Model: VM Option Type C		Date:10-Jul-06	No.: RB861001
Subject: Firmware update procedure for VM Option		Prepared by: K. Moriizumi	
From: 1st Tech. Support Sec. Service Support Dept.			
Classification:	<input type="checkbox"/> Troubleshooting <input type="checkbox"/> Mechanical <input type="checkbox"/> Paper path <input type="checkbox"/> Product Safety	<input type="checkbox"/> Part information <input type="checkbox"/> Electrical <input type="checkbox"/> Transmit/receive <input type="checkbox"/> Other (     )	<input type="checkbox"/> Action required <input type="checkbox"/> Service manual revision <input checked="" type="checkbox"/> Retrofit information

## Firmware Update Procedure (SD Card Only) for the VM Option

Model: VM Option TypeC		Date: 3-Oct-06	No.: RB861002
Subject: Notice at VM card type C installation		Prepared by: K. Moriizumi	
From: 1st Tech. Support Sec. Service Support Dept.			
Classification:	<input checked="" type="checkbox"/> Troubleshooting <input type="checkbox"/> Mechanical <input type="checkbox"/> Paper path <input type="checkbox"/> Product Safety	<input type="checkbox"/> Part information <input type="checkbox"/> Electrical <input type="checkbox"/> Transmit/re

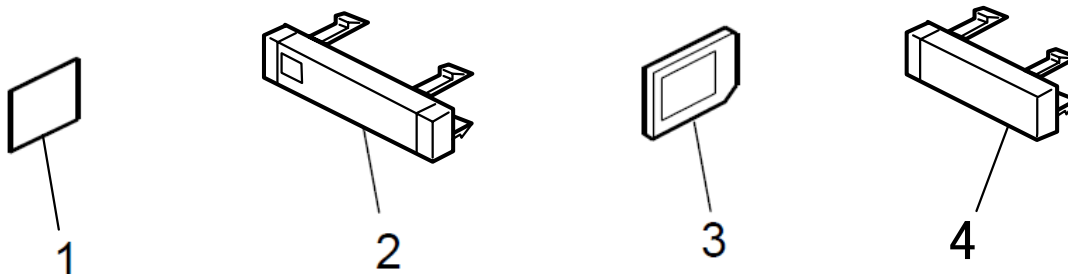
Please apply the following change to your Parts Catalogs.

A new illustration (index 4) was added. As a result, the index number of the following parts was corrected.

Part number	Description	Q'ty	Int	Page	Old index	New index	Note
B2341573	Keytop: TO_KINO:NA	1		3	2	4	
B2341579	Keytop: TO_KINO:EU	1		3	2	4	
B2341574	Keytop: KINO_Menu:NA	1		3	2	4	
B2341580	Keytop: KINO_Menu:EU	1		3	2	4
